寄件者: Chan Richie [REDACTED]
寄件日期: 2026年09月23日星期三 8:55
收件者: Esther Hiu Laam LI/PLAND
副本: Yicko
主旨: SUBMISSION OF INTEGRATED TECHNICAL COMPLIANCE REPORT AND APPENDIX INDEX FOR APPLICATION NO. A/NE-LYT/826 & 881
附件: FIRE SERVICE CERTIFICATE 2026 P2.jpg; FIRE SERVICE CERTIFICATE 2026 P1.jpg; Appendix A (排水01 03092026).pdf; Appendix B (水渠01 03092026 Drainage Proposal.pdf; Appendix C (平面圖01 03092026).pdf; Appendix E (指示牌及地上方向路線 01).pdf; LYT826 Compliance Letter for Conditions 排水 Signed.pdf; LYT826 Compliance Letter for Conditions 消防 Signed.pdf; Appendix D (車流量 動線圖01 03092026) P6.pdf; Appendix D (車流量 動線圖01 03092026) P5.pdf; Appendix D (車流量 動線圖01 03092026) P4.pdf; Appendix D (車流量 動線圖01 03092026) P1-3.pdf
類別: Internet Email

**Proposed Temporary Private Vehicle Park (Private Cars Only)
for a Period of 3 Years in “Residential (Group C)” Zone,
Lots 807 S.E, 827 RP (Part) and 828 RP in D.D. 83, Lung Yeuk Tau, Fanling
Submission for Compliance with Approval Condition (a)
Submission of Revised Drainage Proposal**

SUBMISSION REPORT
FOR
DRAINAGE PROPOSAL DESIGN
FOR TEMPORARY PRIVATE VEHICLE PARK (PRIVATE CARS ONLY)
FOR A PERIOD OF 3 YEARS
LOT 807 S.E, 827 RP (PART) AND 828 RP IN D.D.83
LUNG YEUK

Stormwater Drainage Proposal Plan

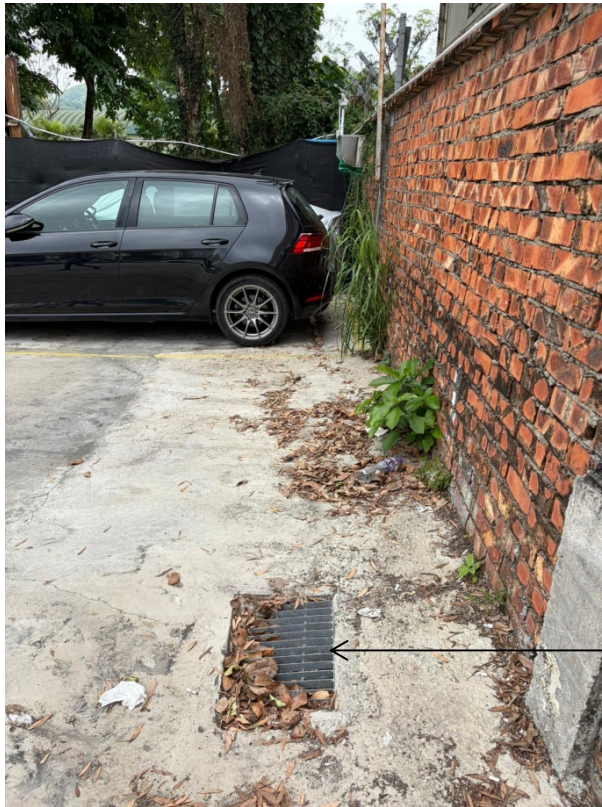
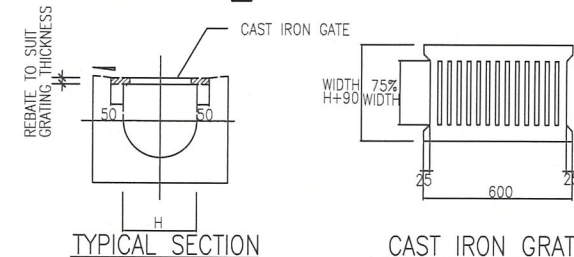
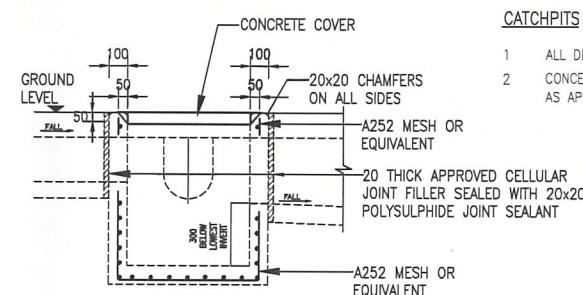
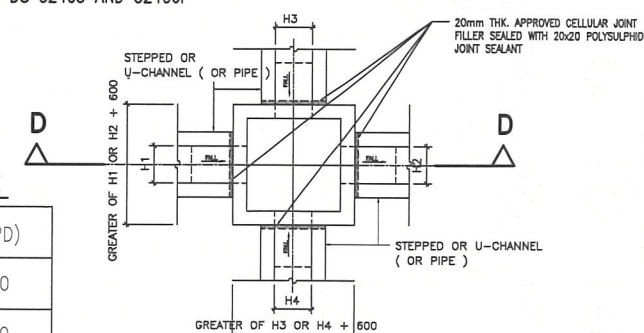
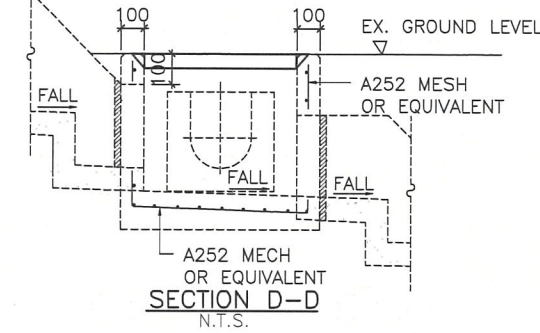
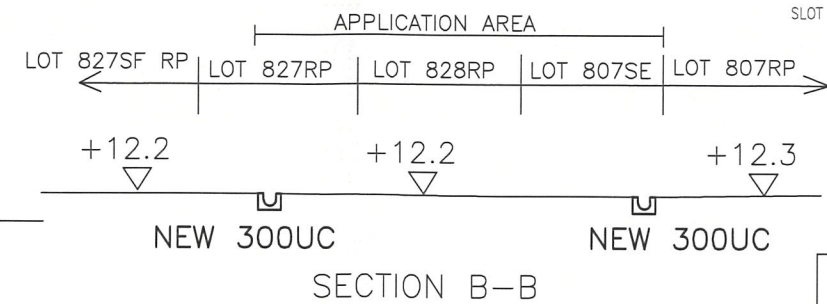
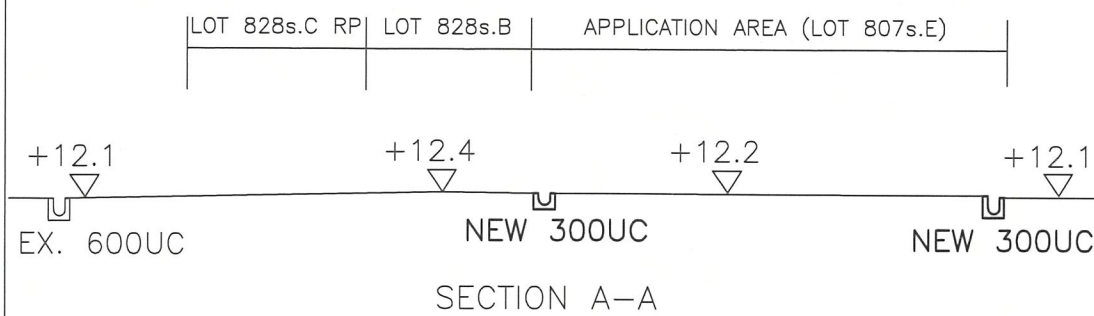
Item	DSD comments	Our Responses
1.	As required in previous comment (provided to the applicant by email on 5.12.2025), engineering drawing to indicate the catchment area, invert level, channel width, catchpits (including those with sand trap) alignment of proposed drainage, planned flow path and downstream discharge point is still outstanding in the resubmission. The applicant may wish to refer to the Technical Note No.1 when preparing the drainage proposal.	The invert level of the proposed catchpit, the alignment and gradient of proposed 300UC and discharge point is provided in the drainage plan in this resubmission.

2.	Please provide various site levels on the drawing to justify the surface flow direction as well as section drawing as indicated below.	The site levels and two sections is provided in the drainage plan in this resubmission.

3.	Please provide the orientation	The photo and its orientation is attached

(direction of view) of each photo on the layout plan as indicated below.	in this resubmission.
4.	The calculation is incomplete. Please provide a complete calculation with justification rather than results.	Noted.

The proposed stormwater drainage works include surface U-channels at the peripheral of the site collecting the runoff from catchments within the site. The U-channels will connect and discharge the surface runoff to the existing government drainage. Catchpits with 300mm sump are proposed at the discharged points of proposed U-Channel to desilt the surface water before discharging to the drainage outside. The proposed stormwater drainage layout plan is shown in **Appendix A**.

LEGEND: — APPLICATION SITE
 (i) → PHOTO TAKING DIRECTION
 NEW 300UC PROPOSED 300mm U-CHANNEL AT FALL 1: 200 (MIN)

CATCHMENT AREA PLAN

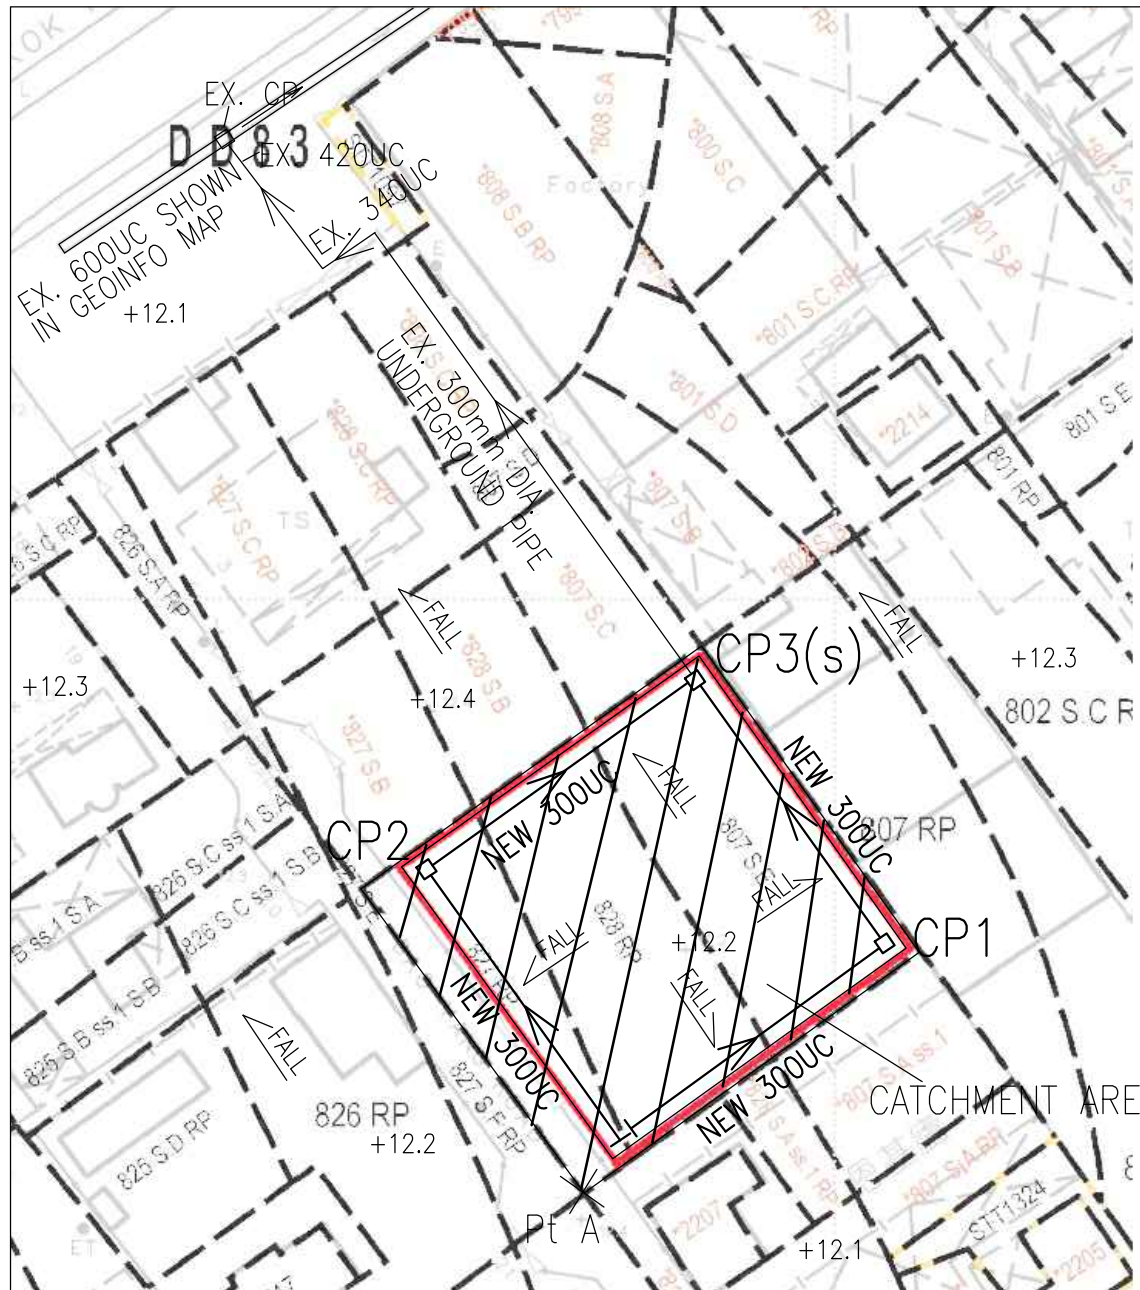
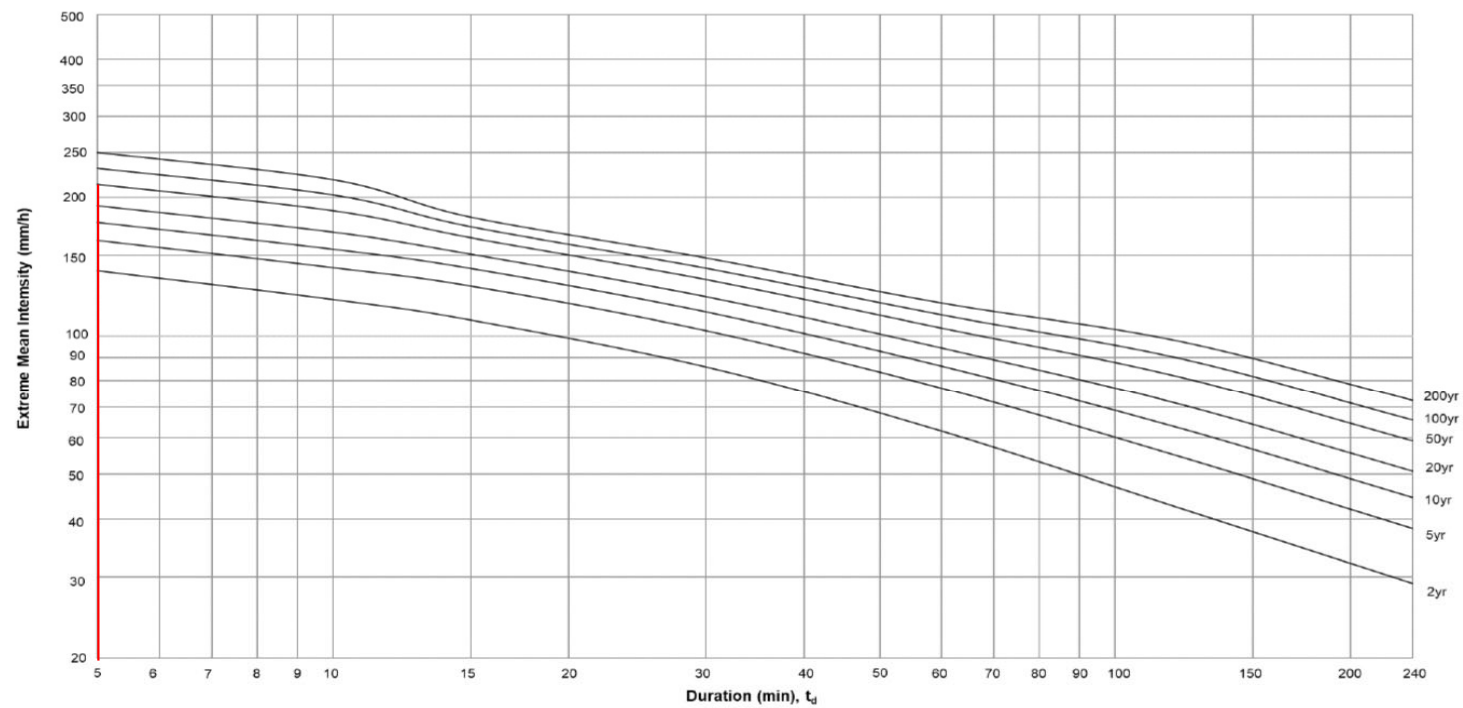
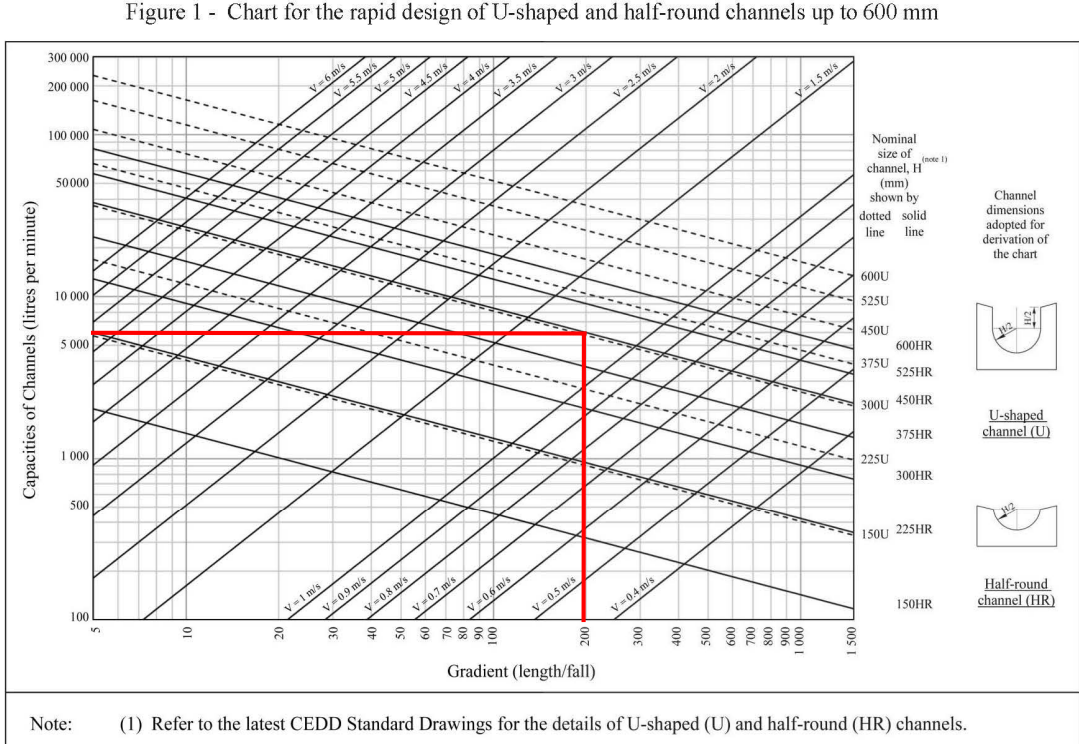
4	The calculation is incomplete. Please provide a complete calculation with justification rather than results	Noted.

Check for the drainage capacity of proposed 300UC

Catchment area, $A1 = 1028 \text{ m}^2$ Assume $k = 0.95$ for paved surface

Average fall, $H = (z_1 - z_2)/L_s \times 100$
 $= 1.27 \text{ m per 100m}$

$T_c = 0.14465 \times L_d / (H^{0.2} \times A^{0.1})$
 $= 4.13 \text{ min}$

$i = 215 \text{ mm/hr}$
 $Q = \frac{kiA}{60} = \frac{0.95 \times 215 \times 1028}{60} = 4059 \text{ lit/min}$ rainfall increase

Maximum capacity = 6000 lit/min > 4059 o.k.

The corresponding velocity = 1.30 m/s < 4 o.k.

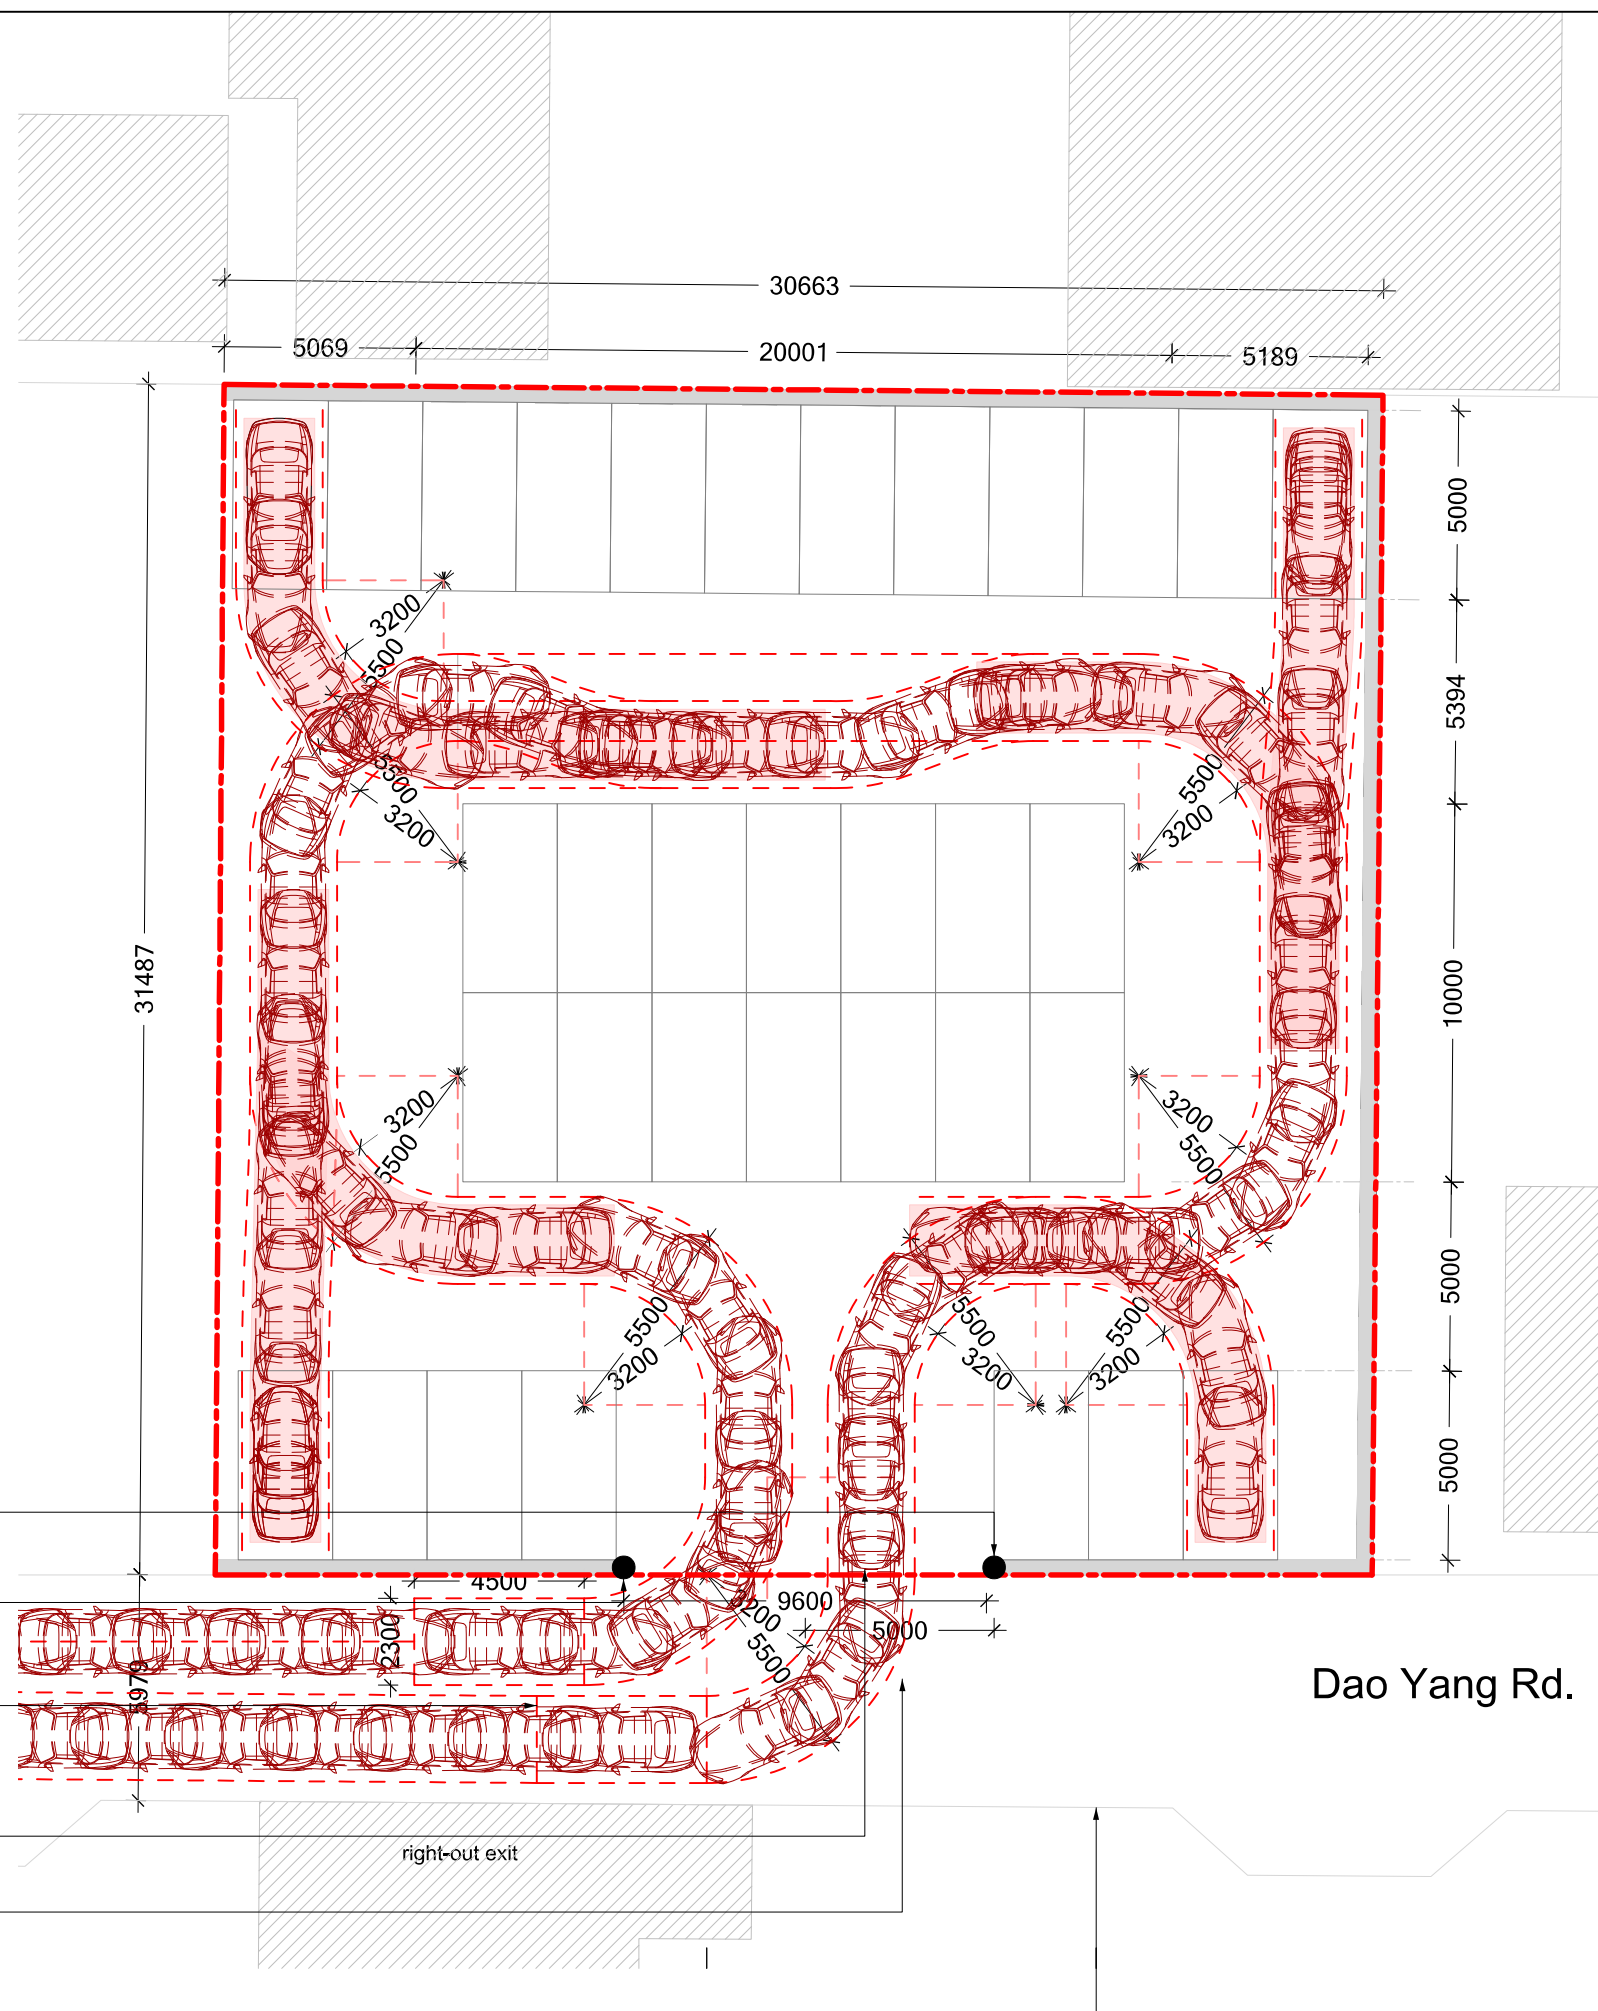
2. The applicant should include the existing traffic flow in calculating the v/c ratio of Dao Yang Road.

- **v/c Ratio for Dao Yang Road:** During the peak hour period and high in/out traffic estimation, the v/c ratio is 0.59, indicating that the traffic flow is well below the road's design capacity, and the traffic conditions are good.
- **Proposed parking lot is intended for long term parking (not daily parking) so the traffic volume in/out to the premise is more likely to be closer to the low estimation**

$$V = 20 + 23 + (34 * 0.5) = 60 \text{ vehicles/hour}$$

$$V/C = 60 / 100 = 0.600$$
